6C Containment Debris Protection for ECCS Strainers

STD DEP 6C-1 (Figure 6C-1)

The original DCD text is presented in *italics*, deletions are shown as ~~strikethroughs~~, and new text in underlined regular font.

Figure 6C-1 Cassette Strainer Cutaway

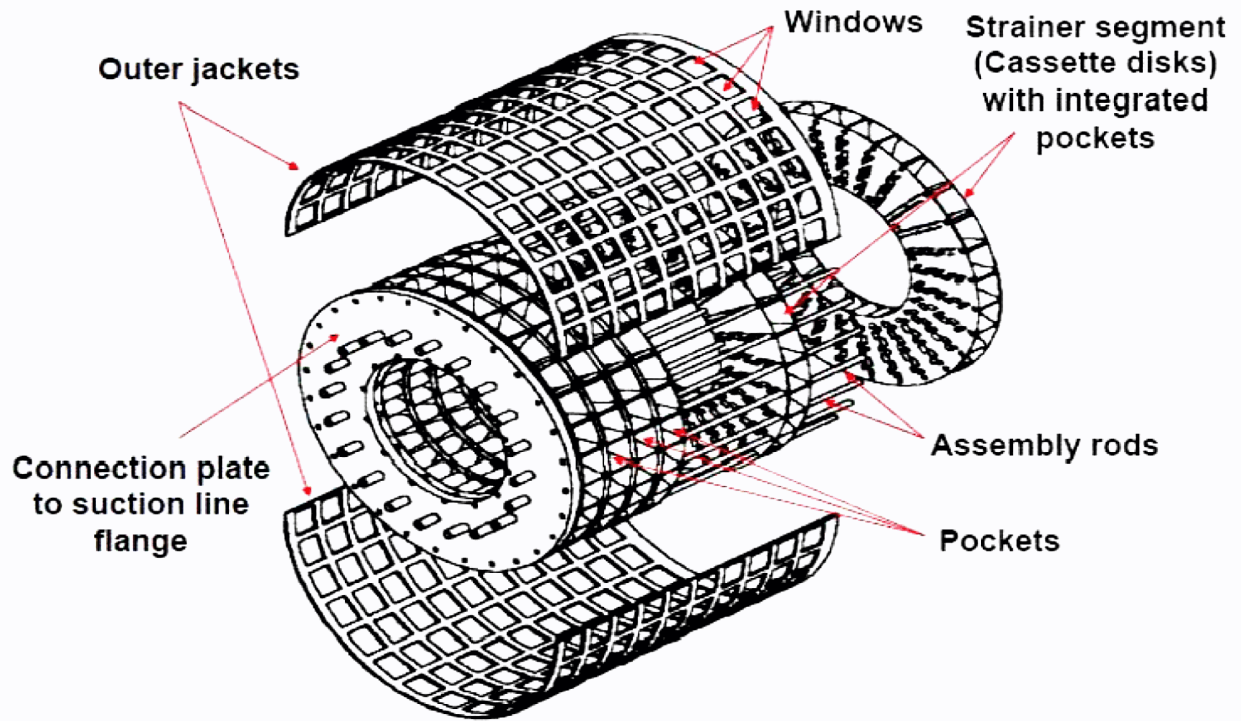
The suction strainers design at Perry preceded and did not meet the current regulatory requirements. The ABWR ECCS suction strainers will utilize a "T" arrangement with conical strainers on the 2 free legs of the "T" a cassette type strainer design. This design separates the strainers so that it minimizes the potential for a contiguous mass to block the flow to an ECCS pump. The design of the strainers will be based on Regulatory Guide 1.82, NUREG/CR-6224 (Reference 6C-4), NUREG/CR-6808 (Reference 6C-5) and the Utility Resolution Guidance, NEDO-32686-A. The cassette type strainer design is based on a set of cassette modules with U-shaped filter pockets attached to the cylindrical outer jacket. Each strainer consists of filter modules, the outer jacket and flange plates on each end of the cylindrical assembly. The filter module is constructed with cassettes which are arranged axially along the strainer axis. One cassette consists of pocket shaped filters which are arranged radially. A cut-away drawing of the strainer is shown in Figure 6C-1. The material used in the cassette type strainer is stainless steel. The cylindrical strainer assemblies are mounted in pairs on piping tees at each ECCS pump suction line. When the ECCS pump operates, the suction flow in the suppression pool runs into all pockets through the outer jacket windows. Each pocket has five flow paths from the inlet through the five perforated walls to the outlet of the pocket towards the cassette strainer. By using the cassettes with the pocket shaped filters, the strainer has an available filter area which is larger per volume than cylindrical and other shaped strainers. The number of cassettes and pockets is adjusted to produce a specific head loss performance for the strainer. To avoid debris clogging the flow restrictions downstream of the strainers, the size of the holes in the perforated sheets is chosen by considering specific flow paths of ECCS equipment and piping (for example, the containment spray nozzle and the ECCS pump seal cooling flow orifices). The strainers will have holes no larger than 2.1 mm.

- (6) ~~(5)~~ *The equipment installed in the drywell and wetwell minimize the potential for generation of debris.*
- (7) ~~The ECCS suction strainers~~ *The cassette-type ECCS strainers meet the current regulatory requirements unlike the strainers at the incident plants.*
